**Joint Regional Planning Panel
(Sydney East Region)**

JRPP No.	2015SYE153
DA No.:	Section 96 modification of the approved development (S96B) comprising of alterations to building adjacent to Coogee Bay Road including additional level on eastern and western wings of seventh floor, additional level on eighth floor, alterations to building envelope and reconfiguration of units resulting in an increase from 36 units to 42 units. Original Consent: Concept Plan and Stage 1 DA for seniors housing development comprising independent living units, a residential care facility with 93 beds and 20 x 1 bedroom serviced apartments in 4 building elements ranging from 5 to 8 storeys in height, basement parking for 154 vehicles and associated works.
Street Address	57-63 St. Pauls Street, Randwick
Applicant	Momentum Project Group
Owner	St. Basils Home
Number of Submissions	4
Recommendation	Approval
Report By	Matthew Choi

1. Executive Summary

Image from the view analysis report (dated 3 August 2012)
Brigidine Covenant (easterly aspect) from the first floor balcony (RL74.84) towards the subject site.

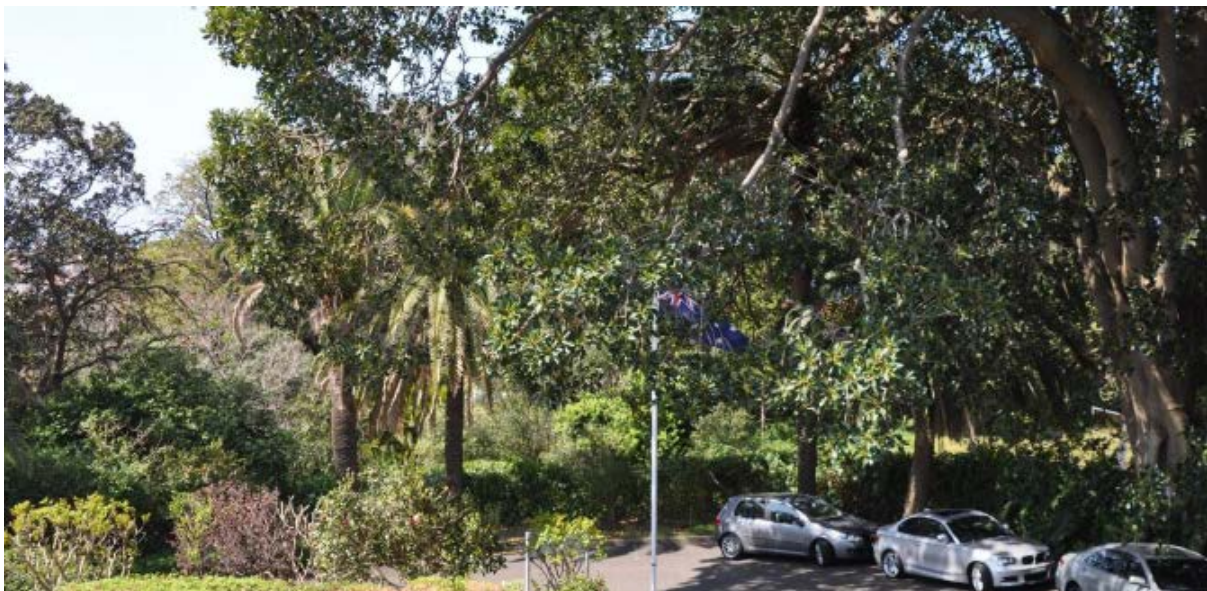
The section 96 modifications to include an additional storey to the northern building block will not give rise to any significant view loss impacts from the neighbouring dwellings including distant water views or prominent natural landforms. The subject site currently enjoys distant water views directly to the east to Coogee Bay given the elevated nature of the development above the Council footpath level and its sitting on the high side of Coogee Bay Road. However, it is unlikely that the modifications to the northern tower will interrupt the distant views from the eastern neighbour given at present the distant water views are largely obscured by the existing natural vegetation and significant trees adjacent to the western boundary between the subject site and no. 7-37 Coogee Bay Road. Notwithstanding this, the increase of the building height from RL79.5 to RL84.2 (as measured from the stair and plant room overrun) is unlikely to block any residual views given that any possible views from the Brigidine Covenant at the finished floor level of the first floor balcony and habitable rooms (RL74.84) and the finished floor level of the third floor level (approx. RL77.84) will be screened by the height of the approved development (RL79.5) and stair/lift overrun (RL82.5). It should also be noted that the subject section 96 modifications does not involve contributing to the scale of the building between the central tower and the northern building block and will not reduce any views from the eastern corridor. In considering the above, the additional building height will not further reduce any views from a direct sightline that may otherwise be reduced from the approved development.
